SUBJECT: Withdraw of the November 16, 2015 Application for Modification, AND Application for Modification with Additional Information for Section 404 Individual Permit and Section 401 Individual Water Quality Certification for the US-74 Monroe Connector/Bypass in Union and Mecklenburg Counties. STIP R-3329 and STIP R-2559, Division 10, Debit WBS Element 34533.1.TA1 in the amount of \$570.

Reference: US Army Corps of Engineers (USACE) 404 Permit issued May 8, 2015; Action ID: SAW-2009-00876
NC Division of Water Resources (NCDWR) 401 Water Quality Certification Permit issued March 6, 2015; NCDWR Project No. 02-0672 V3

The North Carolina Department of Transportation (NCDOT) is in the process of constructing the Monroe Connector/Bypass, as authorized by the USACE and NCDWR as referenced above. NCDOT is requesting a permit modification for ten Permit Sites: 3, 5, 29, 30, 37, 46, 47, 48, 54, and 57, which are detailed below. Two other sites, 6 and 60, have revisions in jurisdictional areas that do not require a permit modification (see below).

Permit Site 3 (Revised Permit Drawings 15 and 16 of 267):

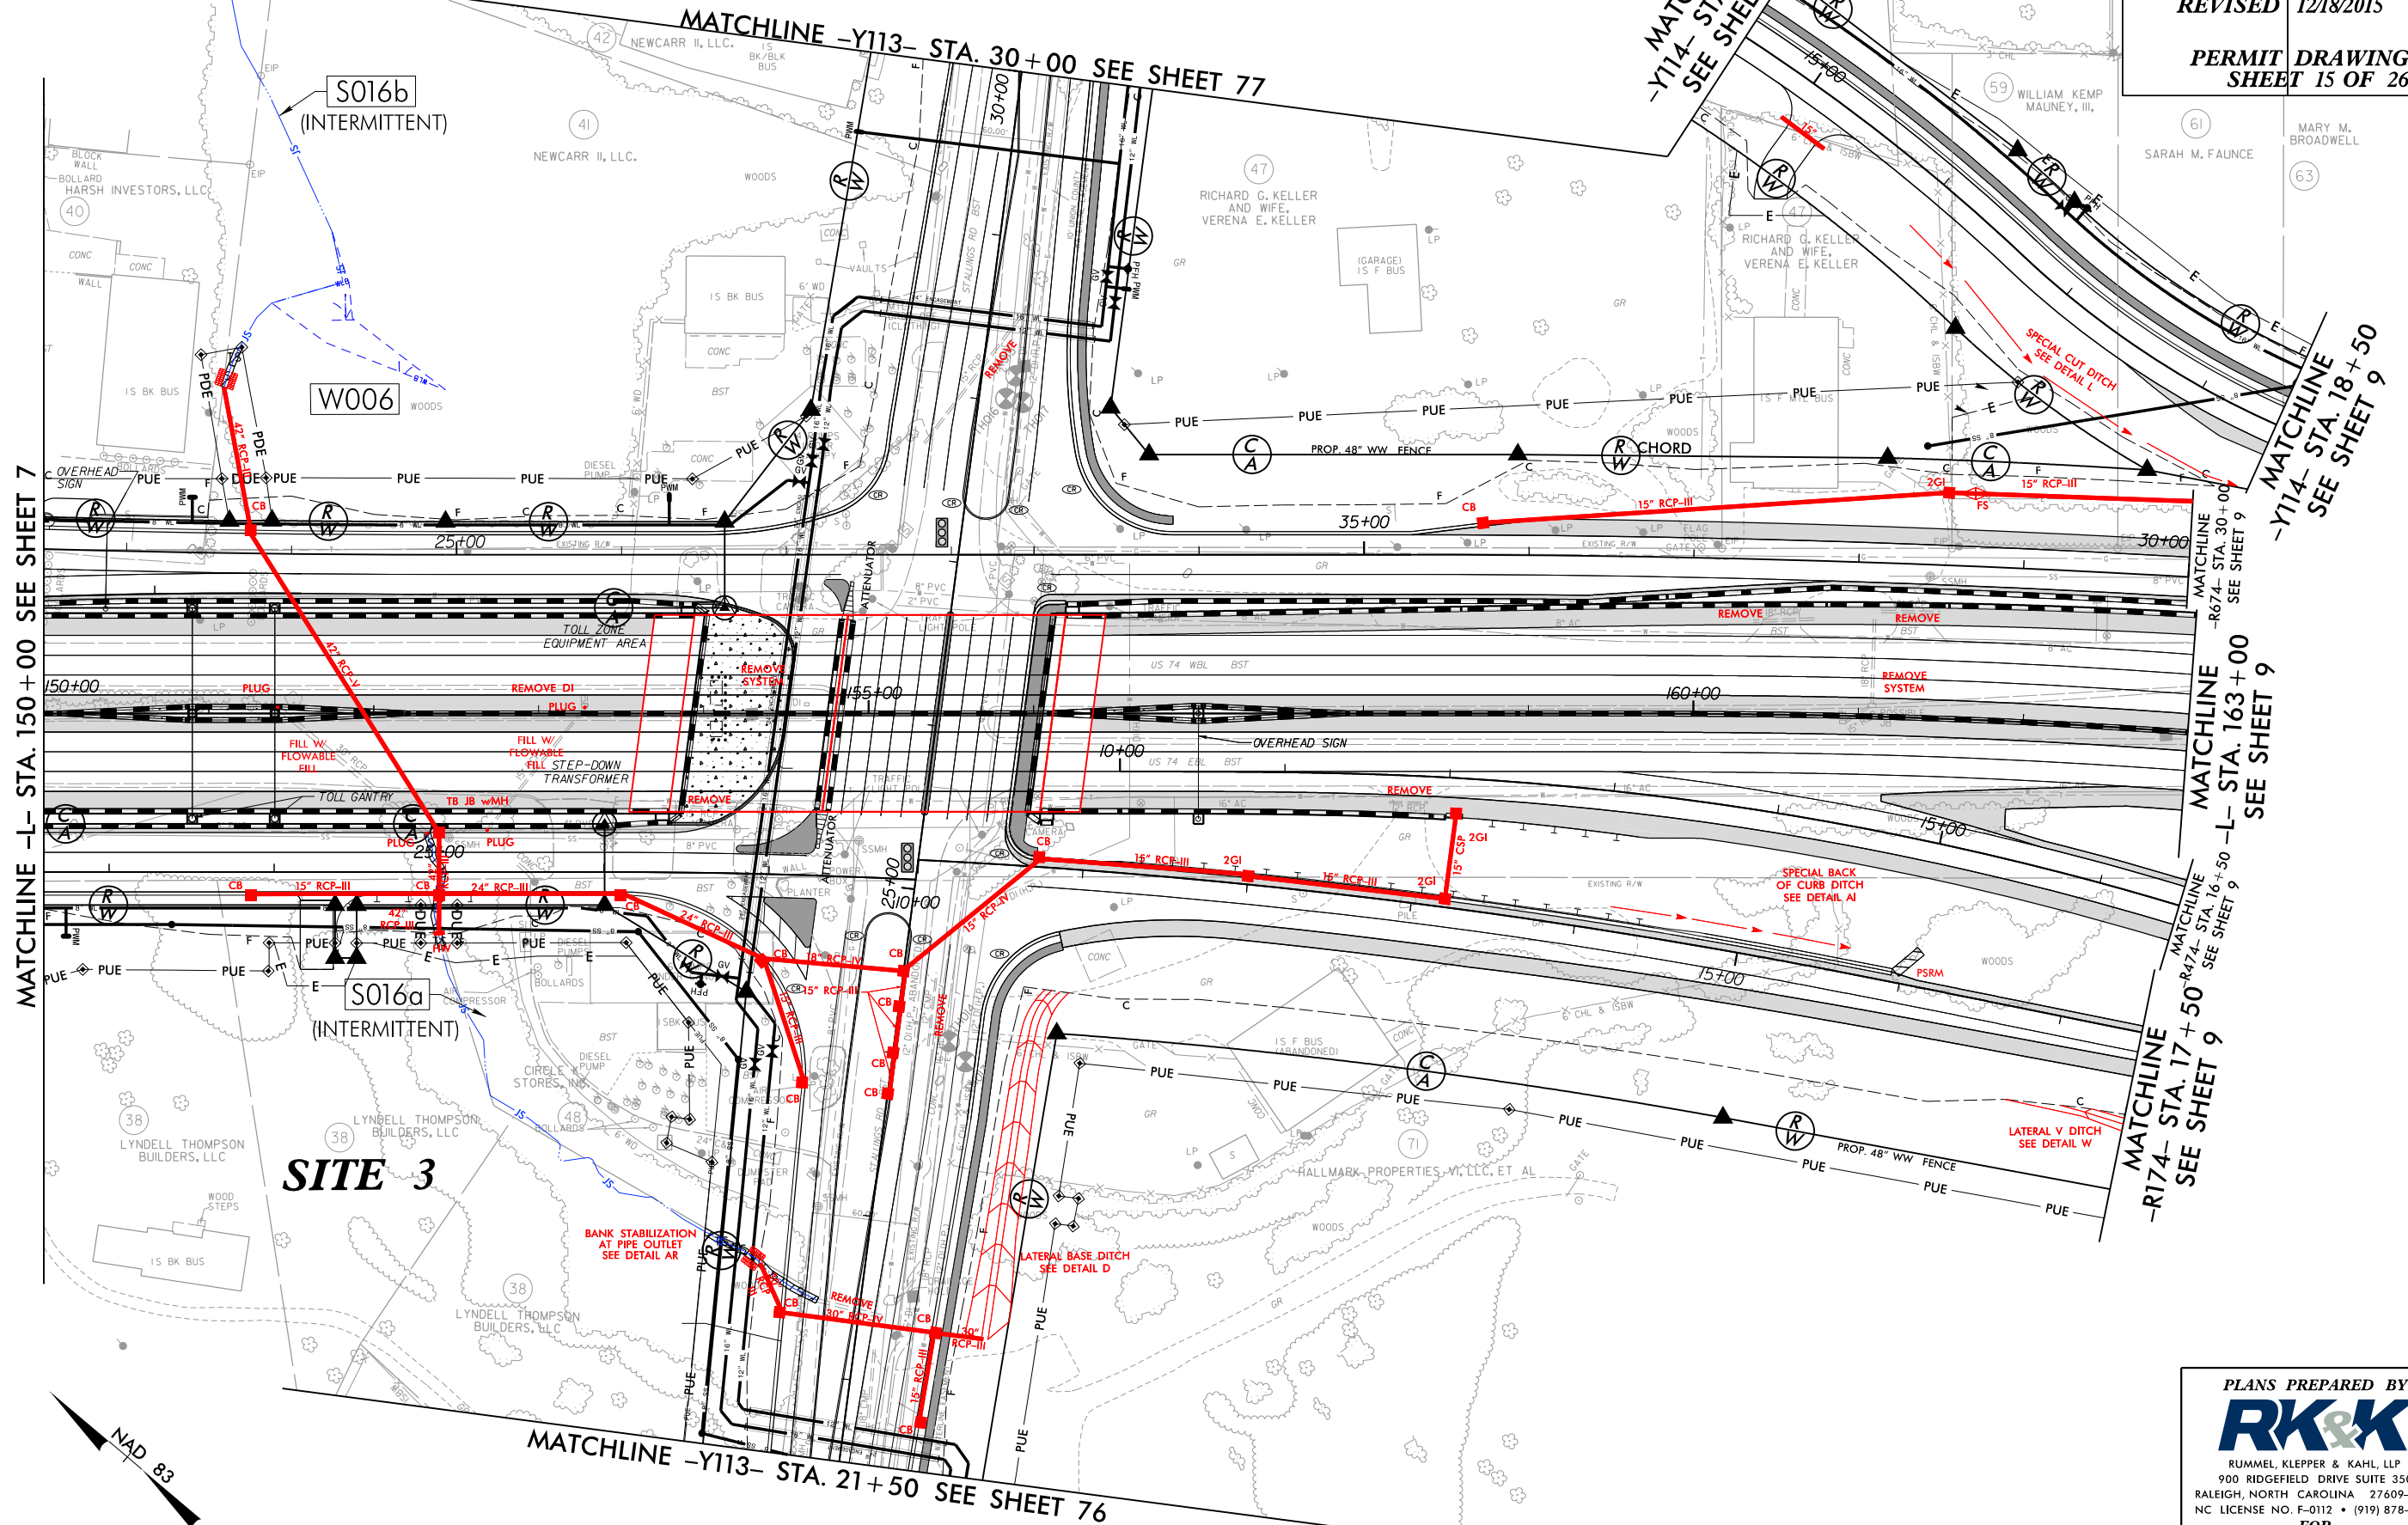
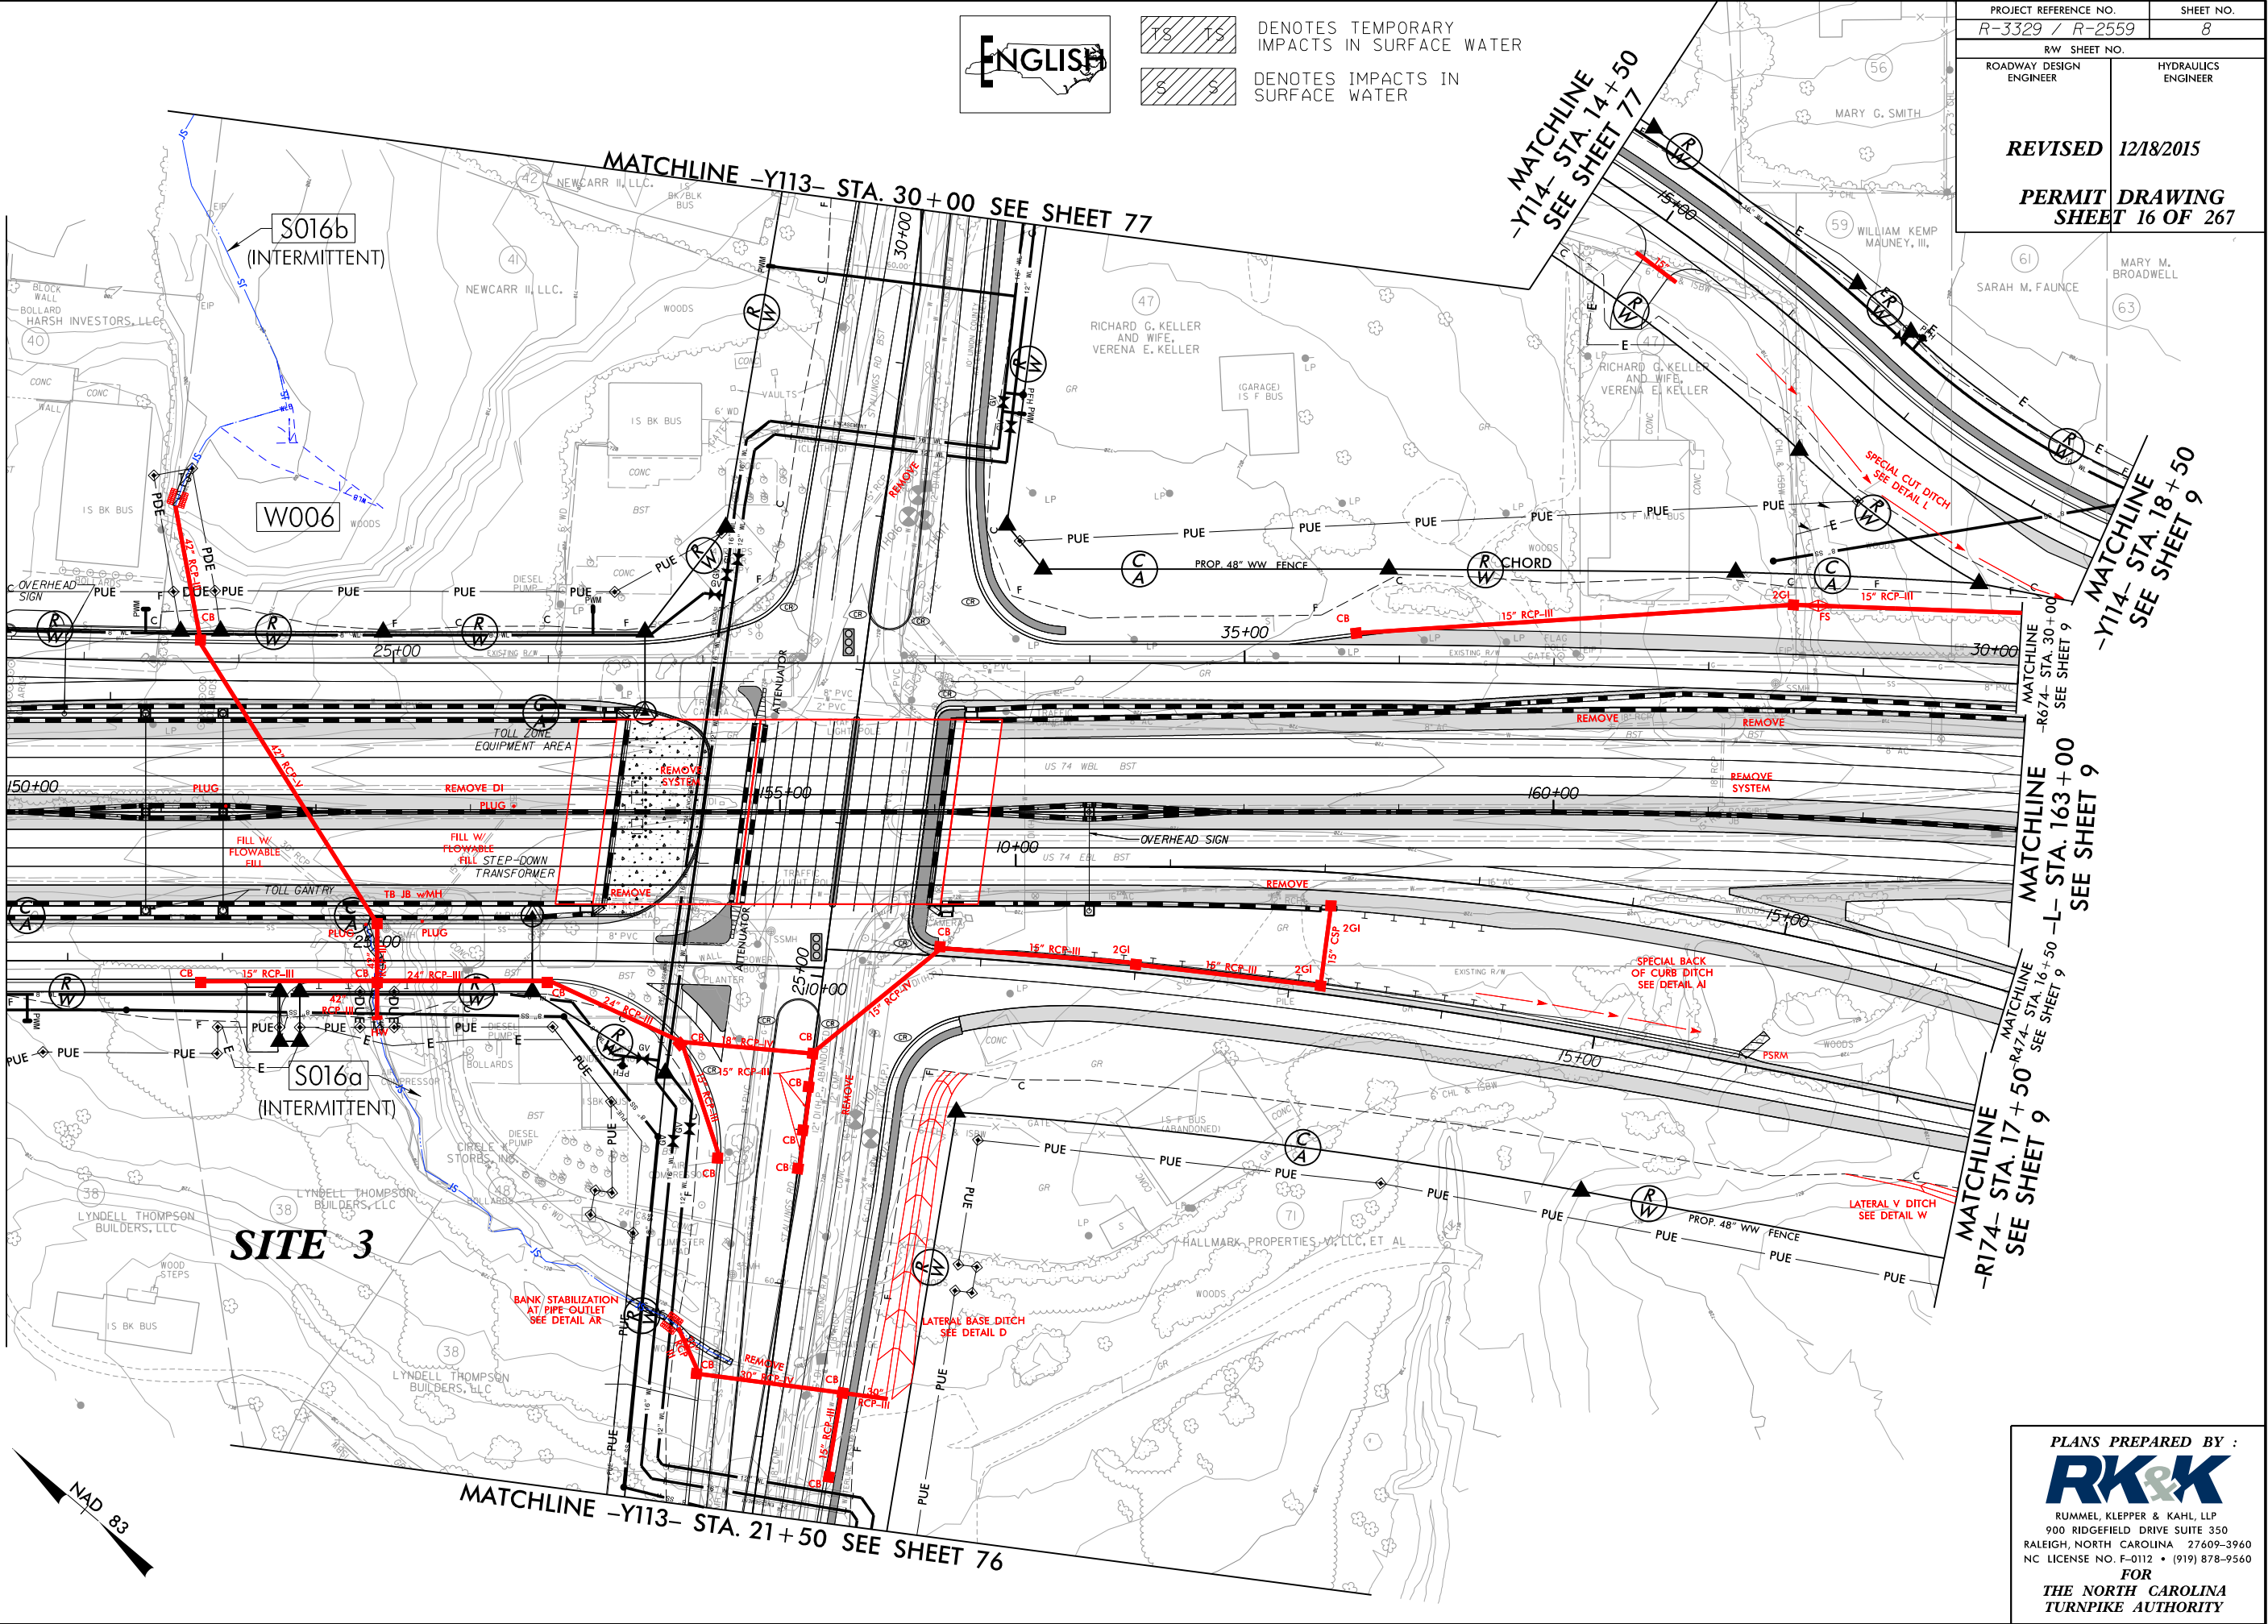
In addition to the previously permitted impacts (130 lf of permanent stream impacts, 24 lf of bank stabilization, and 31 lf of temporary stream impacts), the final designs for the relocation of the sewer/water lines will result in temporary surface water impacts to stream S016 (UT to North Fork Crooked Creek). **There will be 19 lf (< 0.01 acre) of temporary surface water impacts.**
